TECHNICAL RESPONSE MEMORANDUM

RE: **Technical Response Memorandum - Response to Comments received during the Public Comment Period and the February 23, 2022 Public Hearing (Docket # 2022-P-W-0004) on the proposed draft Construction and draft Operations Permit Amendment for Artesian Wastewater Management, Inc.'s Sussex Regional Reclamation Facility (SRRF)**

DATE: August 21, 2023

DATE: 5 DECEMBER 2017
SCALE: AS SHOWN
PROJECT NO. 11278.BA
SHEET: C-35

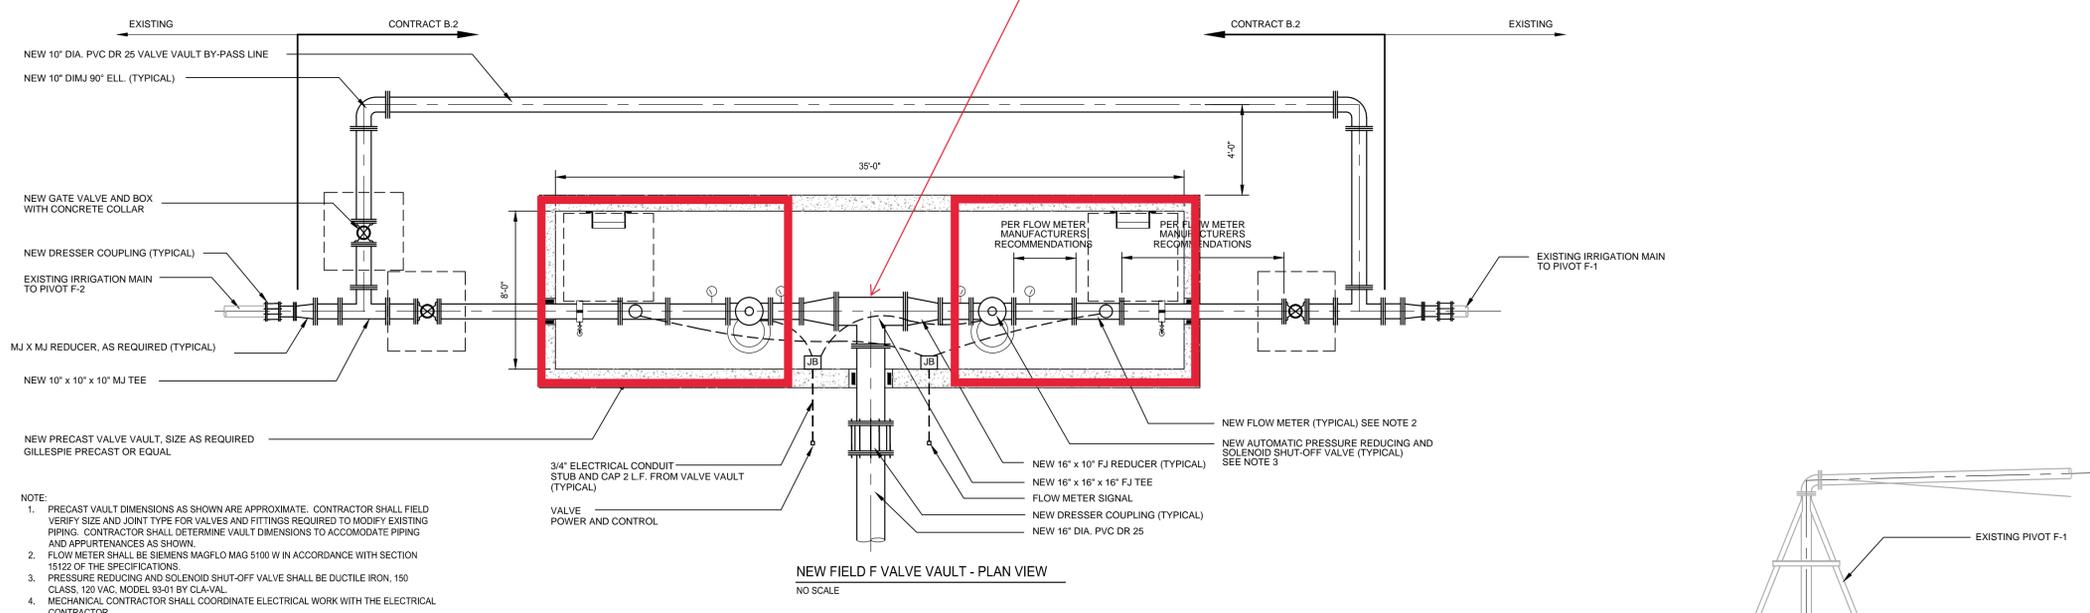
Vault split into two separate vaults with T in between.

Draft Permit Name: Sussex Regional Recharge Facility
State Permit No. 359288-02
Effective Date: March 18, 2020
Amendment Date: **TBD**
Expiration Date: March 17, 2025
Page 3 of 67

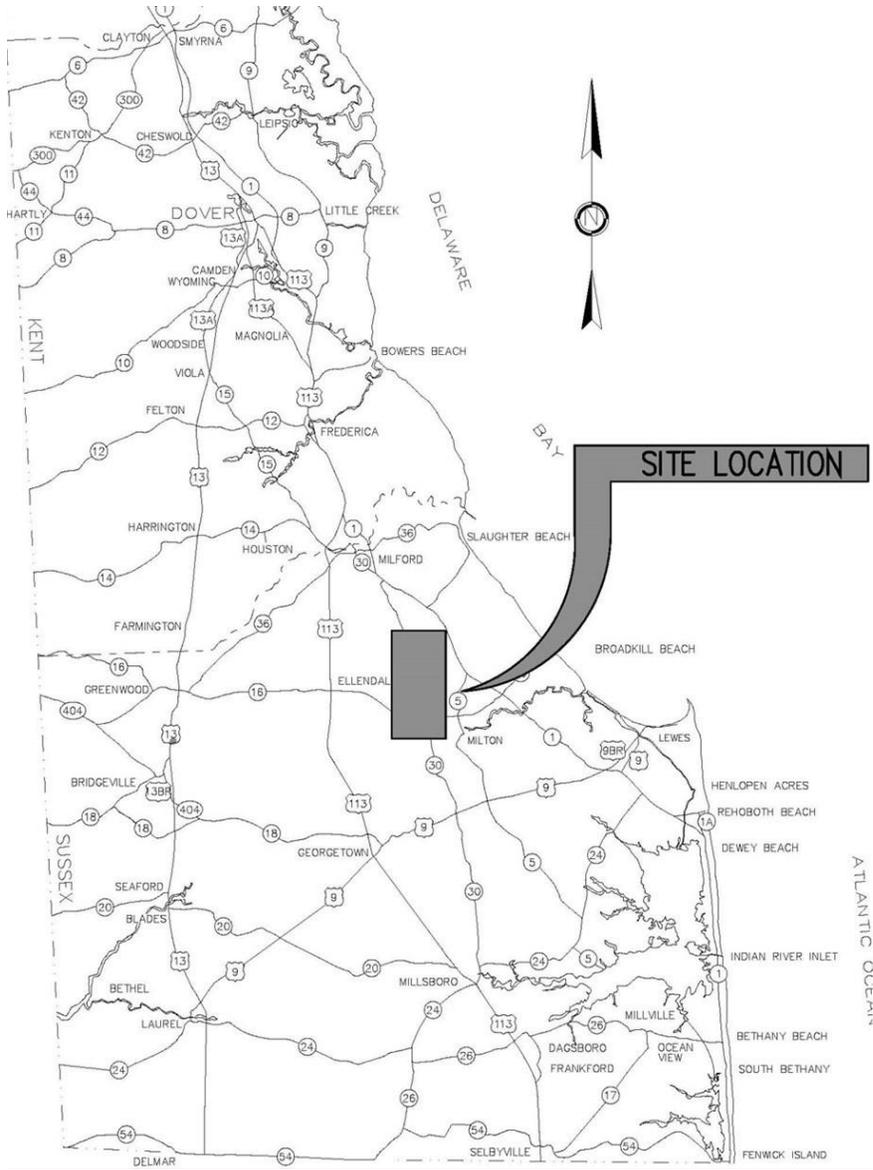
Response: The Division has required thirteen monitoring wells located around Fields F and G to monitor groundwater.

How does the proposed DNREC permit provide tangible evidence to ensure that the wastewater does not leak/seep from the storage lagoons into shallow groundwater?

Part II.A.3 of the proposed revised draft Phase 2 Operations Permit Amendment requires groundwater monitoring from four wells for Field F and nine wells for Field G. Page 3 of the proposed revised draft Phase 2 Operations Permit Amendment shows well locations.

Four wells have been located around the property that the existing storage lagoon and proposed lagoons are located on. The four wells are depicted on Page 3 of the proposed revised draft Phase 2 Operations Permit Amendment. The four wells are also depicted in Appendix A.2 and A.5 of the February 2021 DER (pdf pages 52 and 66). In addition, monitoring well 1-F (258634) is downgradient of the existing storage lagoon. Please note, SRRF began Phase 1 operation in July 2021.

PROCESS FLOW DIAGRAM PHASE 1 [taken from 2019.07.17 Drawings G-3 and G-4]

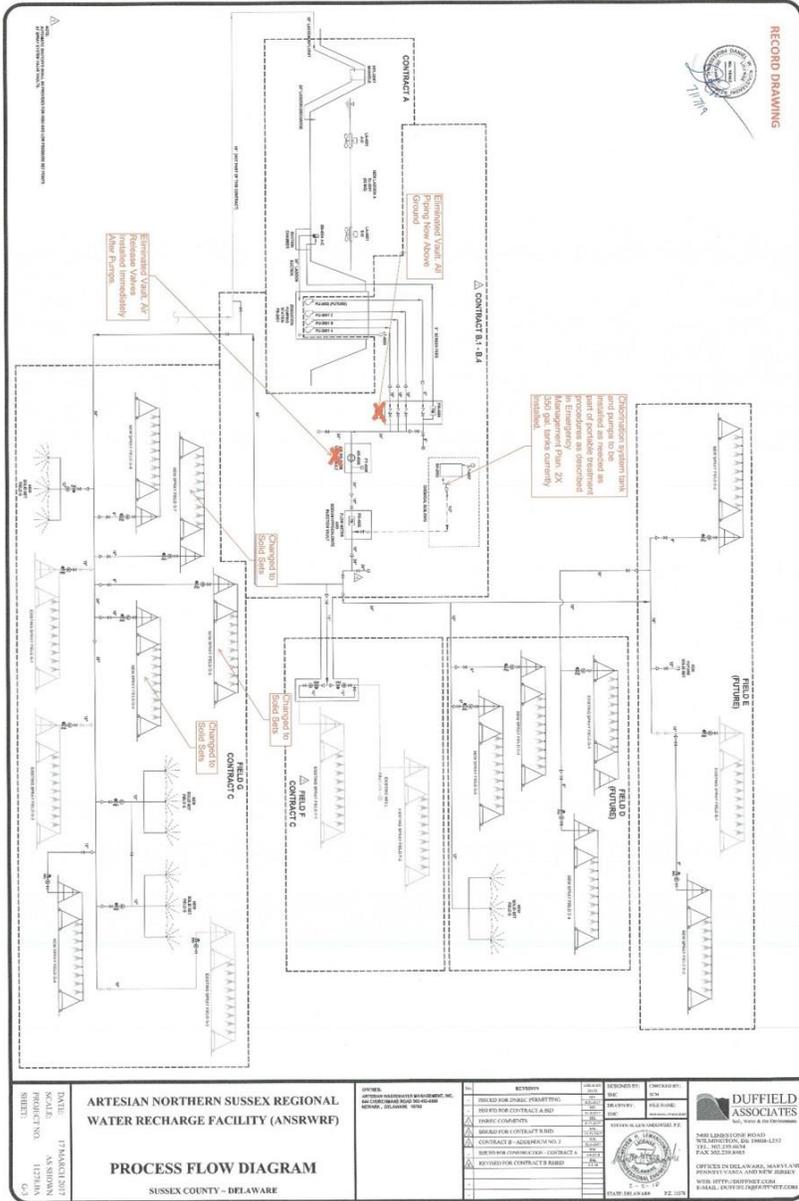
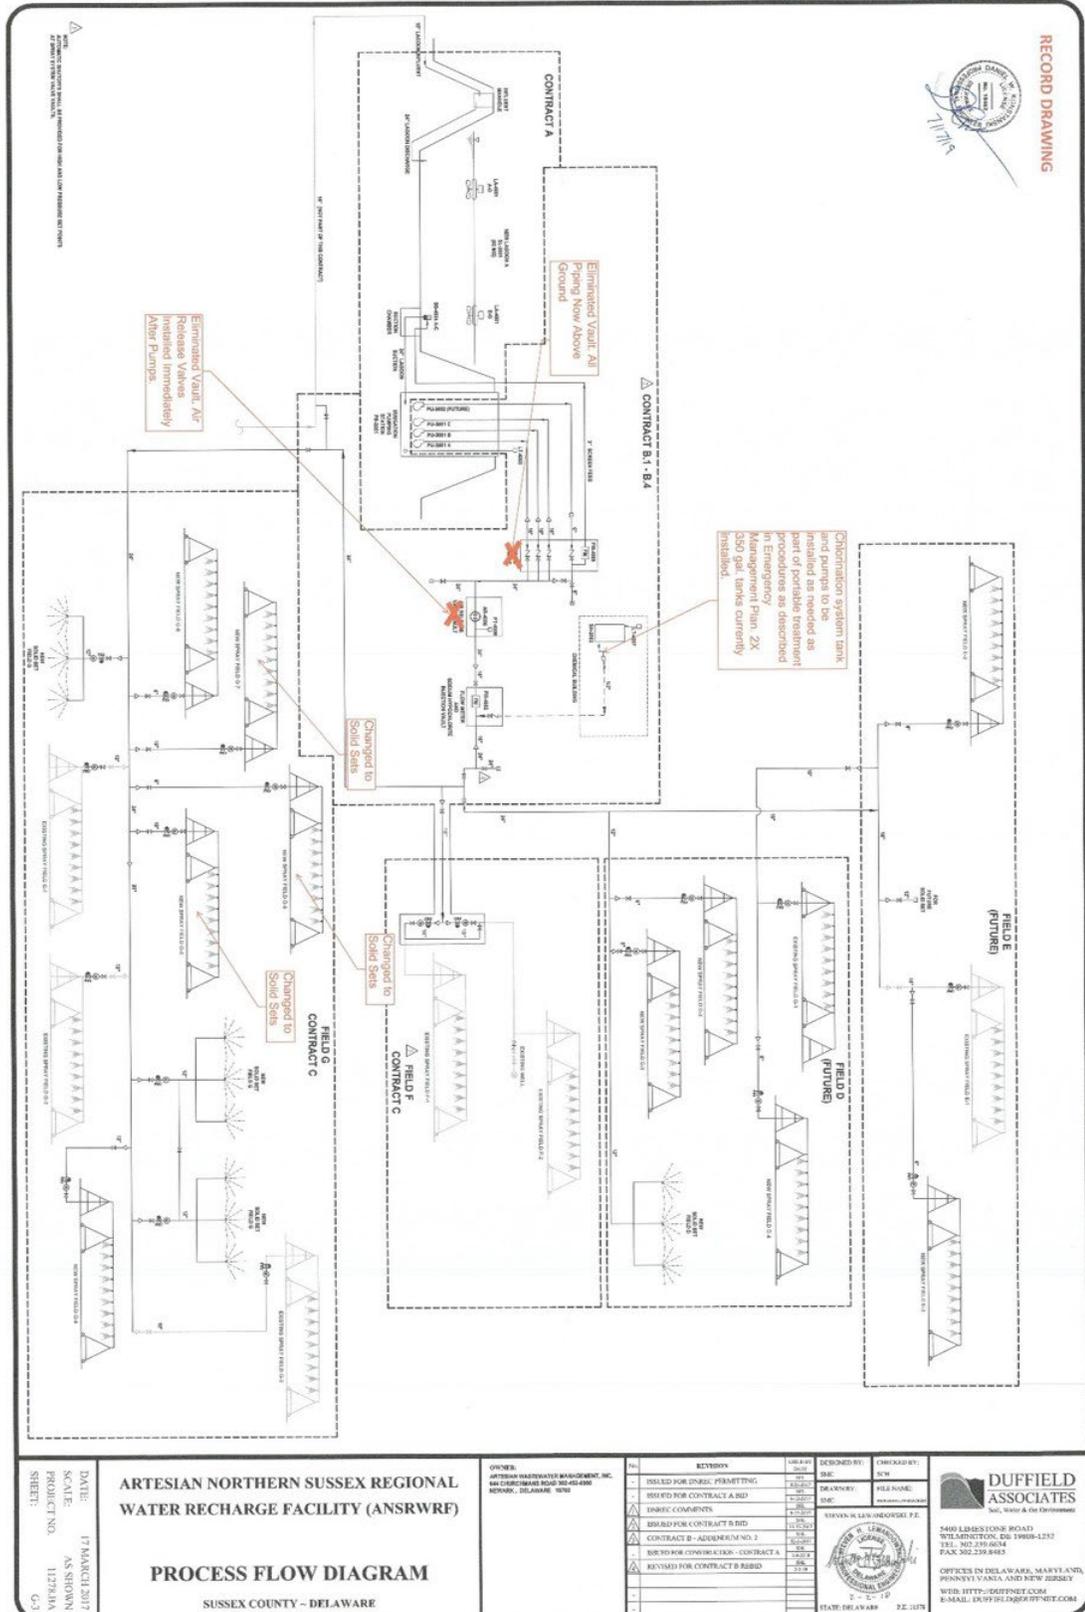
Public Comment: “Provide a process flow diagram depicting operations under diversion. The Process Flow Diagram provided in the application Drawings (pdf page 3) does not note a return line and appears unclear as to how the diversion process would be implemented.”

AWMI Response: Please see the diagrams contained in Appendix A [of application submission]. This depicts the three diversion modes described previously.

The Division has concluded that the proposed management of the emergency diversion would properly divert and manage flows in accordance with the intent of Section §6.3.2.3.2.4 of the Regulations which stipulates diversion requirements for wastewater that fails to meet operating specifications. In addition, the management of any diverted wastewater upon implementation of the contingency plan will minimize the potential for odor concerns because the wastewater will be recirculated back through plant for treatment as soon as possible.
